SUBJECT: U.S. NUCLEAR REGULATORY COMMISSION (NRC) APRIL 19, 2010 ONSITE
OBSERVATION REPORT FOR THE SAVANNAH RIVER SITE SALTSTONE
FACILITY

**U.S. NUCLEAR REGULATORY COMMISSION (NRC) APRIL 19, 2010 ONSITE
OBSERVATION REPORT FOR THE SAVANNAH RIVER SITE SALTSTONE FACILITY**

Figure 1: Disposal Cell Depiction (not to scale)

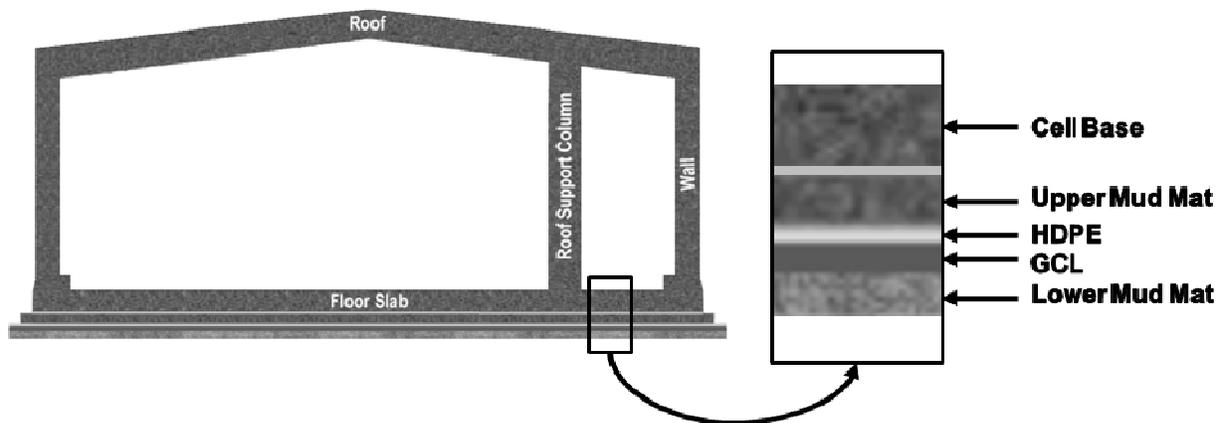
The staff's visit was prompted initially by an interest in observing the hydrostatic test of disposal cell 2B, however, shortly before SRR began the test, multiple damp spots were evident at points

around the base of the cell (Figure 1). Due to the presence of damp spots on cell 2B, the hydrostatic test of cell 2B was postponed and investigations were performed to determine the source of the spots.

The NRC staff visited the site to observe the progress of examining the root cause of the damp spots. At the time of the observation, the vendor CROM was in the process of removing the outer layer of shotcrete on the outside base of the cell at the points exhibiting damp spots. In addition, spots noticed at a lower point (between the upper mud mat and the cell floor, note Figure 1) provided sufficient evidence for portions of the upper mud mat to be removed enough to see the circumference of the cell floor under the base of the cell. SRR staff walked NRC staff around the circumference of the cell and requested multiple photos be taken at various points during this portion of the tour (available at ADAMS accession number ML101460045). In all, 33 damp spots were identified at various spaces around the circumference of the cell. These spots were slightly damp to the touch, but were mostly evident by sight. NRC staff asked various questions pertaining to the timing of the damp spots and any correlations the location of the spots had with construction materials, components, etc. that might have been noticed by SRR or CROM staff. A question of note asked by NRC staff was what effect the presence of damp spots will have on the hydro-test procedures, specifically, will any chemical or visual tracers be used in future hydro-tests (e.g. cell 2A hydro-test). SRR staff responded to the question by saying that insertion of a tracer will be considered for the hydro-test of cell 2A. Damp spots are of interest to the NRC staff because their unexpected presence and the corrective actions to repair them could each have some effect on assumptions made in the performance assessment pertaining to vault performance.

A red dye tracer was then added to the water to distinguish between water inside the cell and water from the surrounding environment, outside the cell.

The NRC staff will continue to monitor actions being taken to investigate the cause of the spots.
